Approved Section 4.55 (1A ) Modification Application

No MOD 24/11703 (DA 10115 MOD 1)

### S.4.55 MODIFICATIONS TO DA 10115

#### REPLACEMENT OF THE MOUNT PERISHER DOUBLE AND TRIPLE CHAIRLIFTS WITH A SIX SEAT DETACHABLE CHAIRLIFT & ASSOCIATED WORKS

**Figure 8: Proposed modified Stage 1 top station elevations**

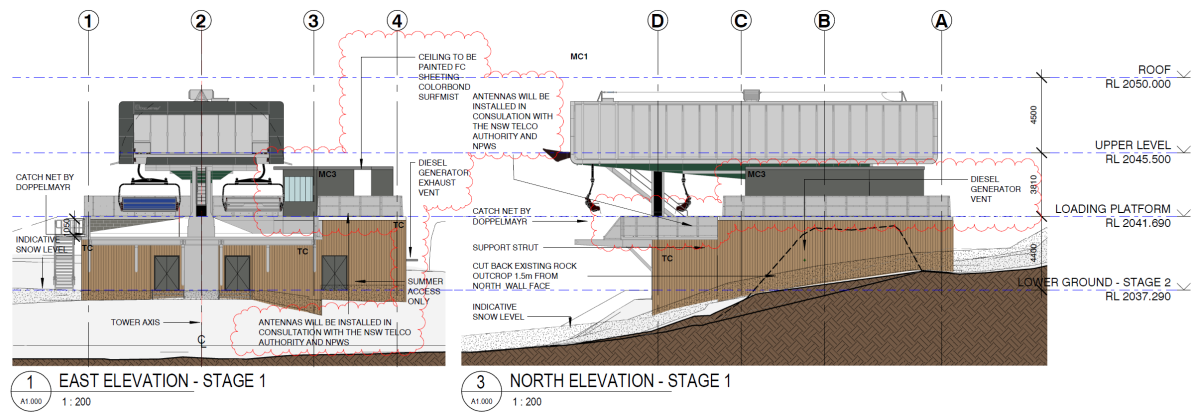
Whilst the lower ground floor will still be constructed, with a slightly modified layout, above the ground floor slab, the D-line standard Doppelmayr structure will be constructed for the 2025 season, allowing for the lift to open and operate. An extract of the modified Stage 1 top station plans is provided below.

Other modifications to the top station include:

- Removal of external steel decking and associated access door at Ground level.
- Rearrangement of control hut space.
- Removal of maintenance area and associated platform.
- Addition of Southern external access stairs.
- Change of finish to Lift control hut to Metal Cladding
- Addition of internal access doors to Lower Ground level spaces.
- Addition of perimeter balustrading to Ground Level.

*Figure 12: Proposed modified Stage 1 bottom station elevations*

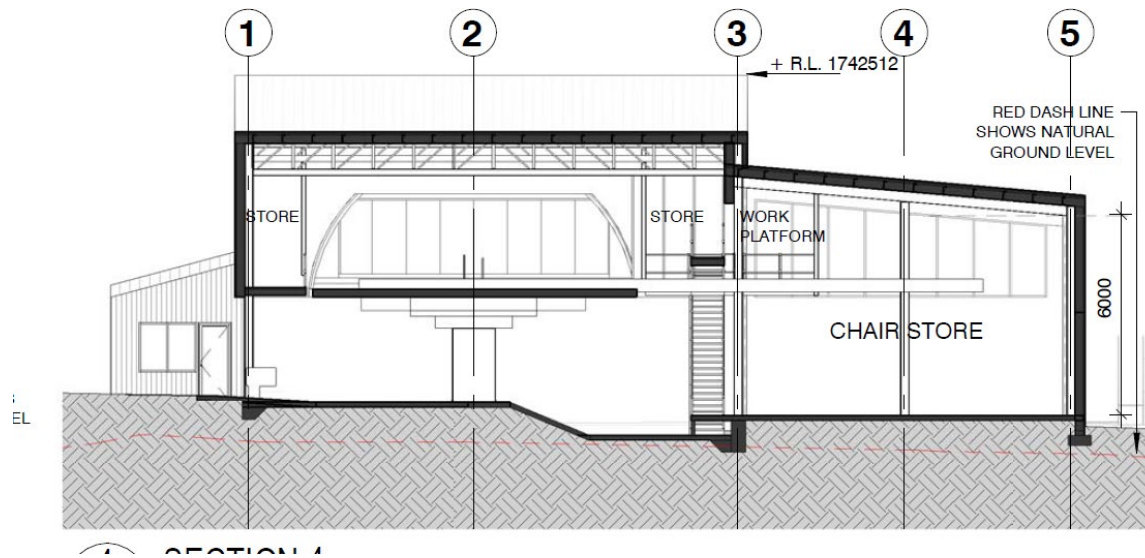
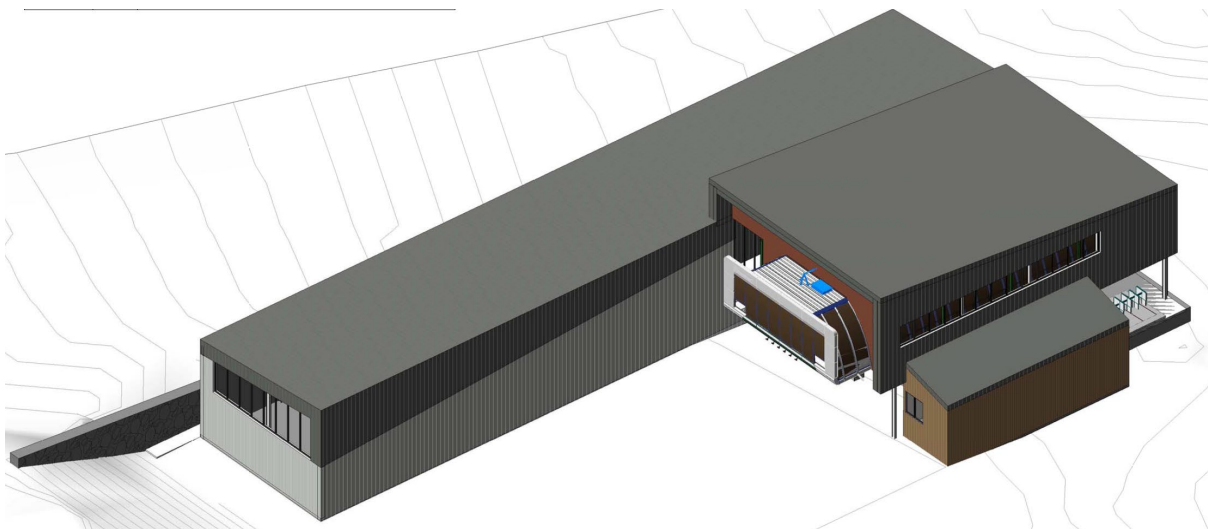
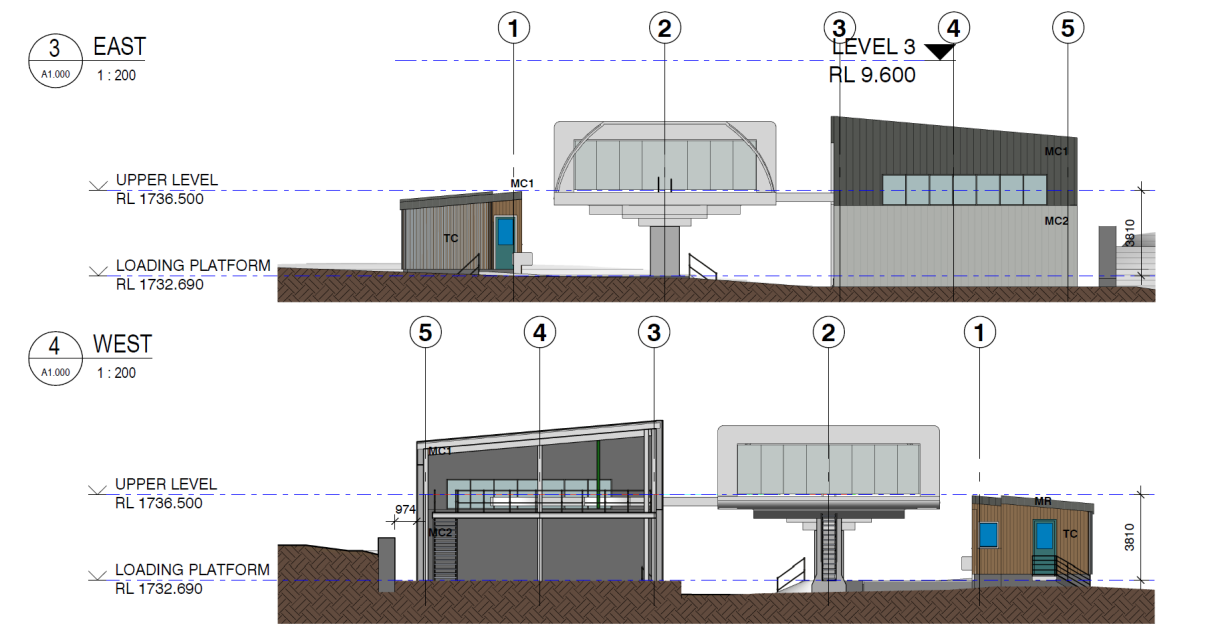
With the lower ground floor foundations and slab still being constructed so it can accommodate a future enclosed building, the staging and modified plans will allow Perisher to open and operate the lift without the enclosed building. Should Perisher choose to erect this later, they can do so as Stage 2 for the bottom station, obtaining a separate Construction Certificate at that time. An extract of the modified Stage 1 bottom station plans is provided below.

Other modifications to the bottom station include:

- Change of retaining walls from Gabion walls to Beton Blocks.
- Rearrangement of ski chairlift maintenance area to the eastern end of the chair shed store.
- Rearrangement of control hut floor plan with addition of personnel access stairs.
- Change of control hut cladding from timber to metal cladding.
- Addition of personnel access door to chair storage shed.
- Addition of access stairs on path to chair storage shed.
